Changes to Clause 85 due to comment #64

Changes to Clause 86A due to comment #63

Changes to Clause 86A due to comment #64

Figure 86A-4—Return loss limits of mated HCB-MCB

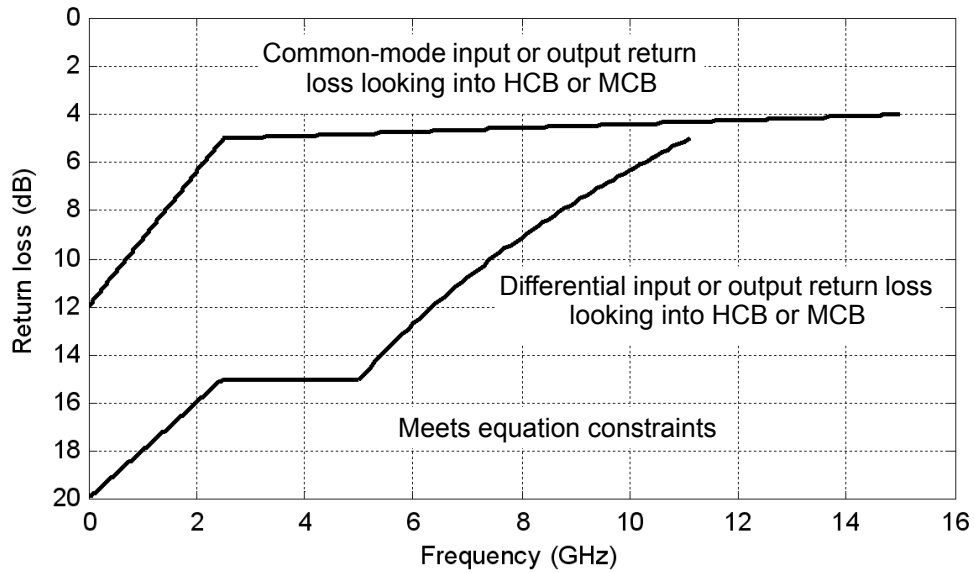
The limit on the common-mode return loss in decibels of the mated HCB and MCB is given in Equation (86A-8) and illustrated in Figure 86A-4.

$$Return_loss(f) \geq \begin{cases} 12 - 2.8f & 0.01 \leq f < 2.5 \\ 5.2 - 0.08f & 2.5 \leq f \leq 15 \end{cases} \text{ dB} \tag{86A-8}$$
